**Architectural Review Board Staff Report  
July 13, 2026 Meeting**

**6600 NEW ALBANY-CONDIT ROAD OFFICE  
FINAL DEVELOPMENT PLAN**

LOCATION: 6600 New Albany-Condit Road (PID: 222-000640)  
APPLICANT: Rob Riddle  
REQUEST: Final Development Plan  
ZONING: Infill Planned Unit Development (I-PUD): 605 Neighborhood Office District  
STRATEGIC PLAN: Village Center  
APPLICATION: FDP-32-2026

Re: 6600 NA Condit Rd.  
Final Development Plan

*Image: Proposed site layout, showing the buildings, pavement and parking, and general landscaping.*

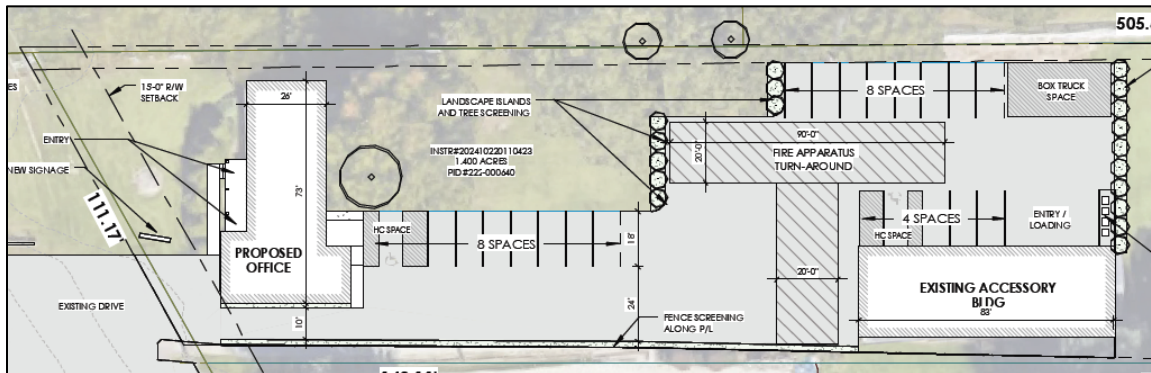
- The distance of the pavement from the southern lot line is unclear. Staff recommends a condition of approval that the parking lot pavement be at least five feet away from the southern property line (condition #1).
- The zoning text permits a maximum lot coverage of 80 percent, which includes both buildings and pavement. The applicant is proposing a lot coverage of approximately 42 percent. The requirement is being met.

4. The applicant has proposed three blue spruce evergreen trees around the parking lot area; however, two deciduous canopy trees are required. Staff recommends a condition of approval that at least two of the three proposed evergreen trees be deciduous canopy trees, subject to staff approval (condition #3).

1. The parking lot pavement shall be at least five feet away from the southern property line.
2. All landscaping requirements shall be met.
3. At least two of the three proposed evergreen trees shall be deciduous canopy trees.
4. A bike rack shall be installed on the site.
5. The Engineer's comments regarding both the final development plan and Traffic Access Study shall be addressed by the applicant.

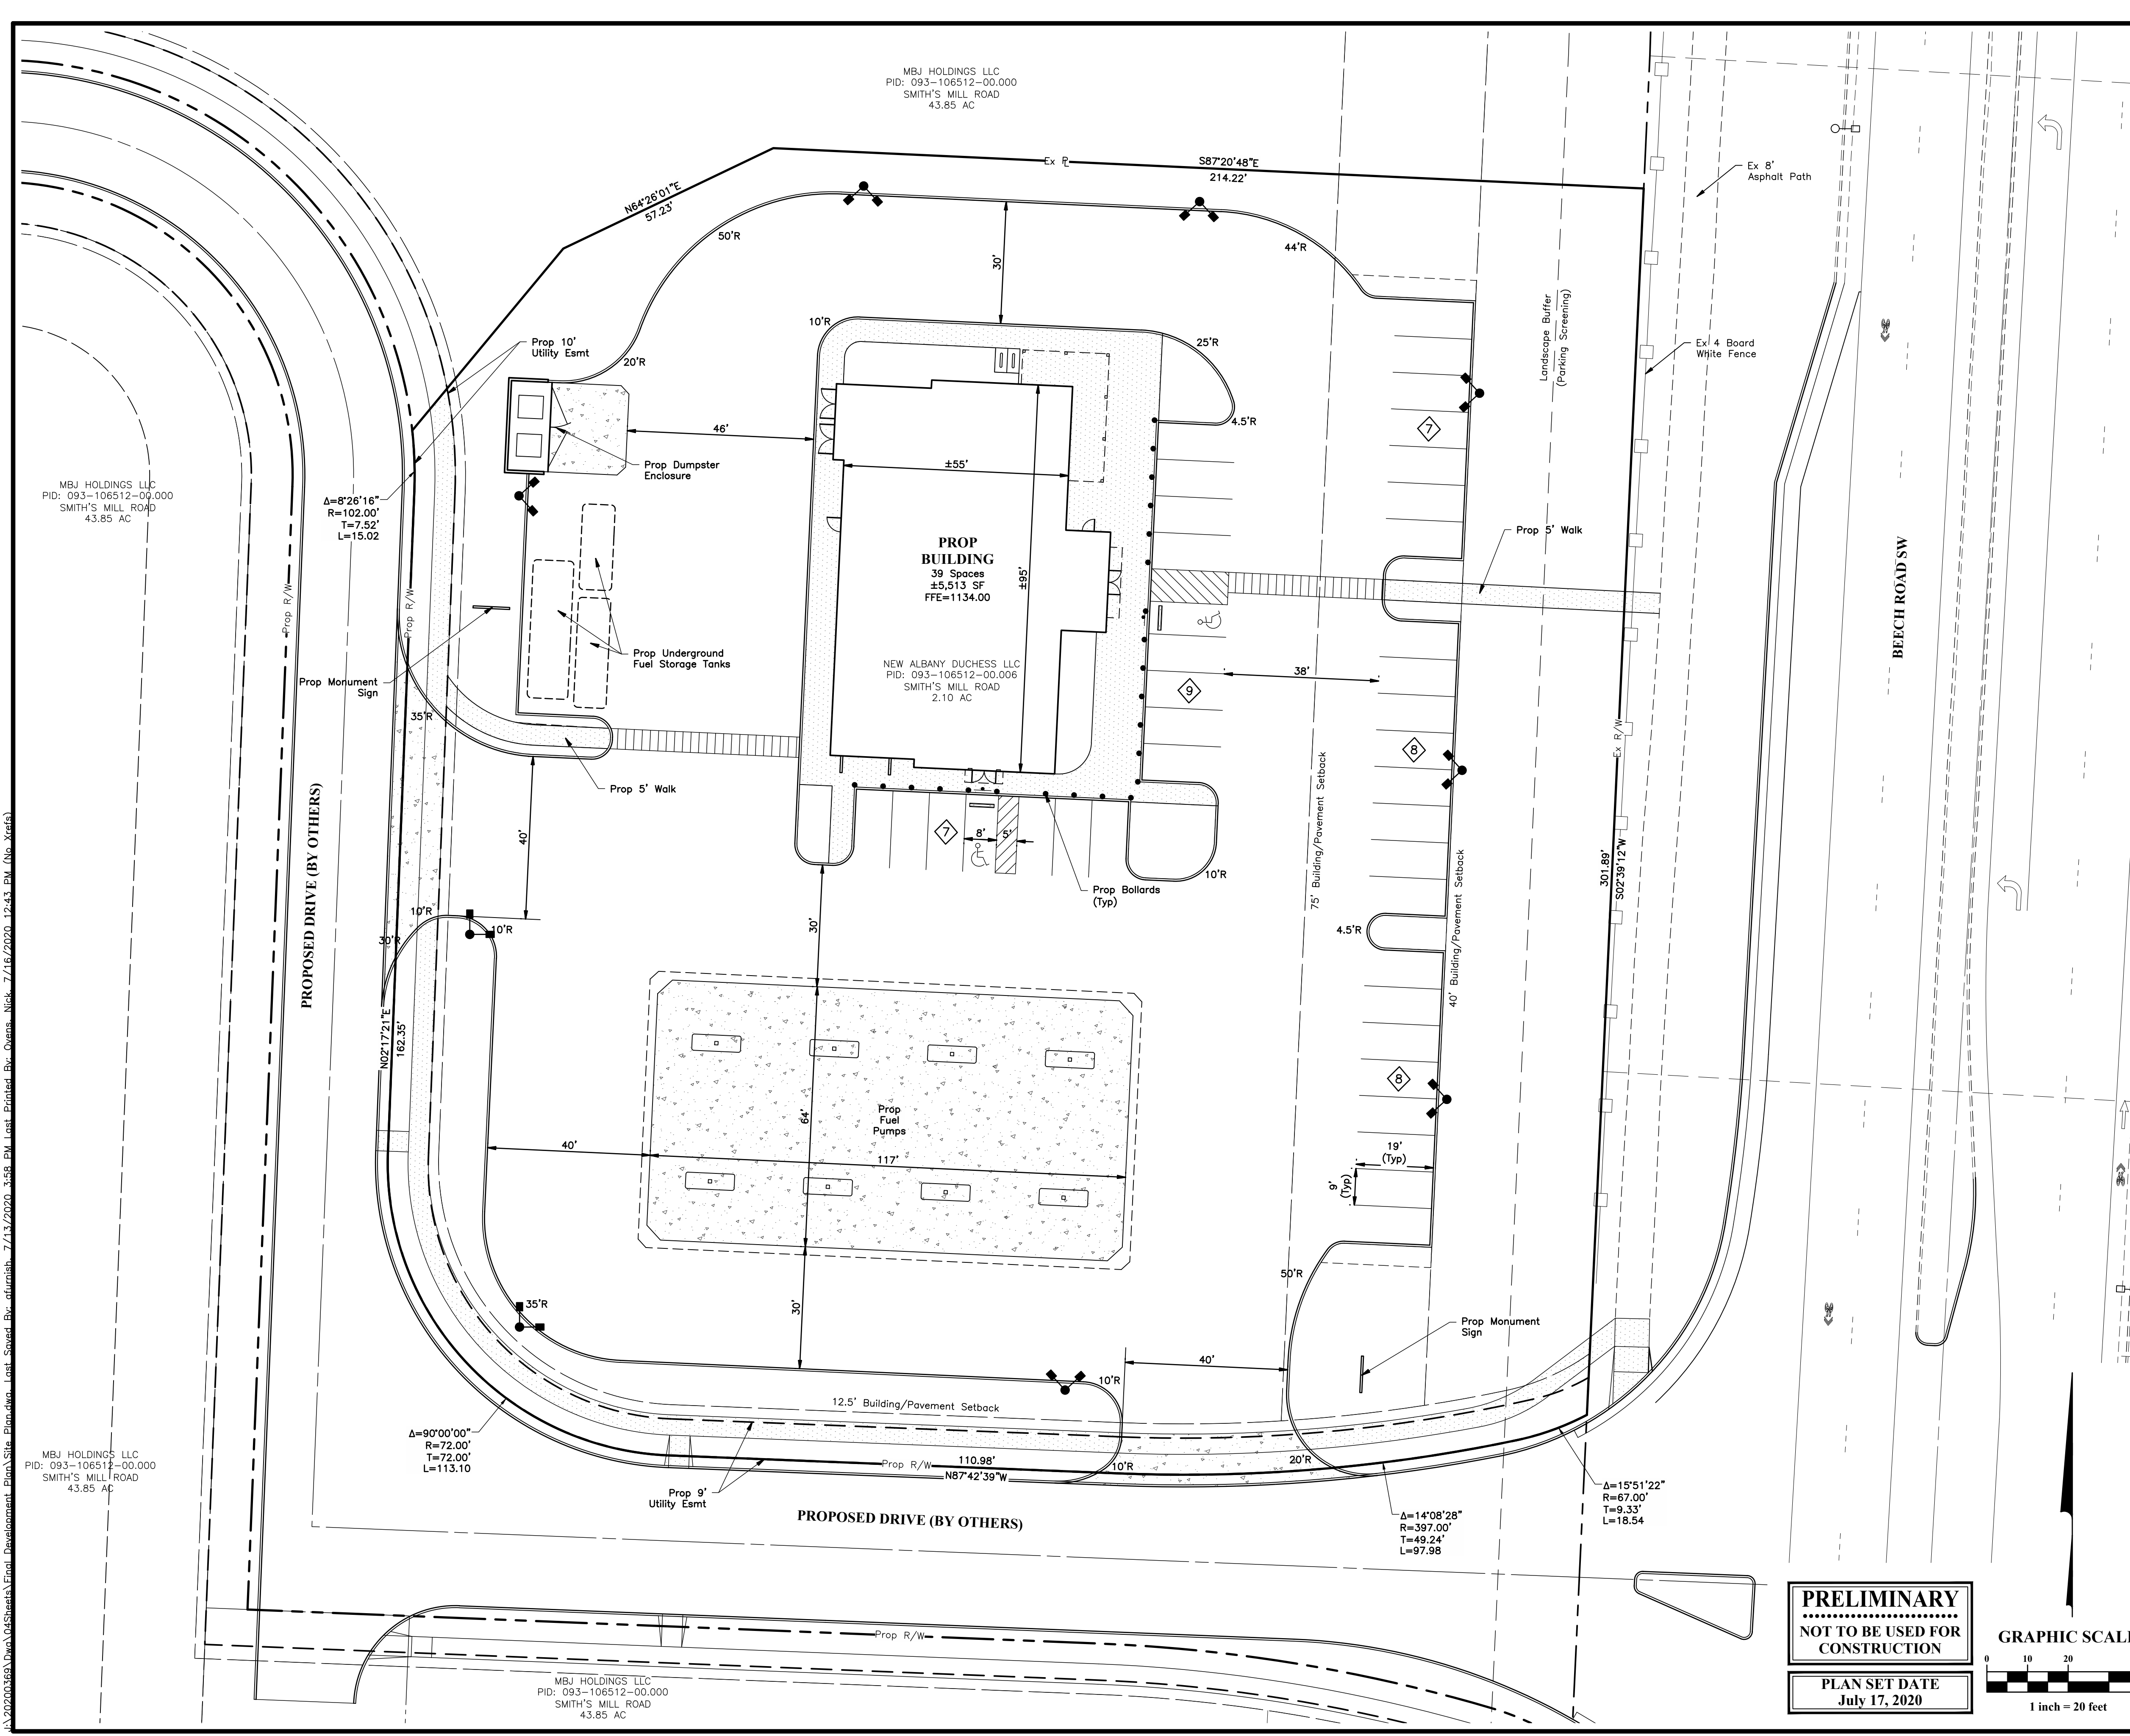
1. Refer to Exhibit A provided with this memorandum. Add the notes and signature block indicated to the Cover Sheet.
2. Provide evidence that all existing private well/septic systems have been abandoned in accordance with all applicable environmental regulations.

## Sight Distance Exhibits

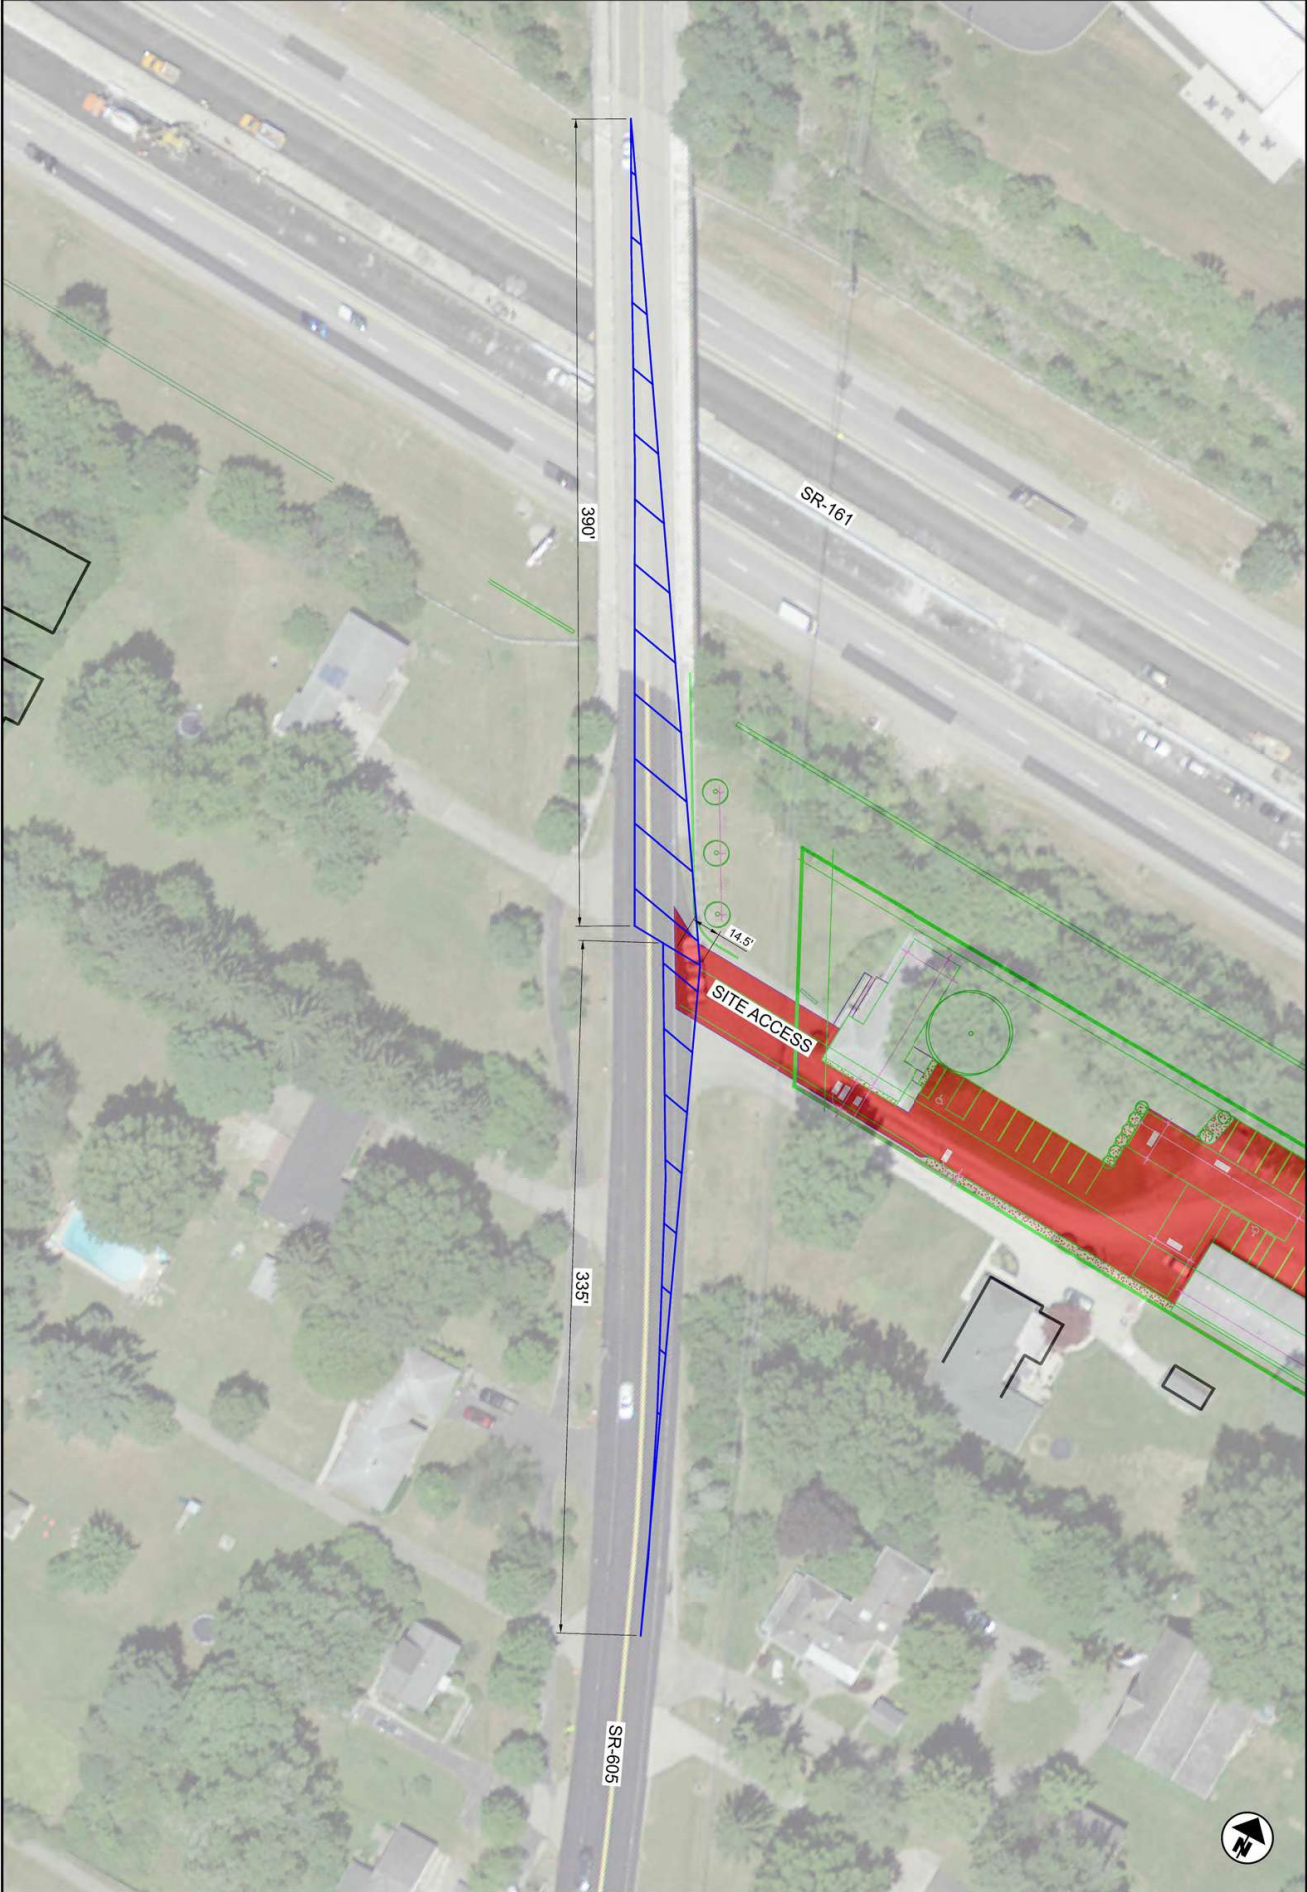
- Capacity analysis results at the office driveway intersection are acceptable for the redeveloped site.
- The horizontal sight distance review shows a slight overlap/conflict with the existing guardrail on the north leg of the intersection. We would like C-M to verify in their driveway design that the driveway's vertical profile does not preclude westbound office patrons from seeing northbound over the existing guardrail when exiting. Top of rail height is typically a 31" and standard driver eye height is 42". Due to the noted elevation drop of the existing SFR driveway on Streetview, please verify that the clearance is enough for motorists to see over the guardrail as they wait to pull out. If not, the city may want to request a slight buildup on the first portion of the driveway to ensure vertical clearance is available to address this.
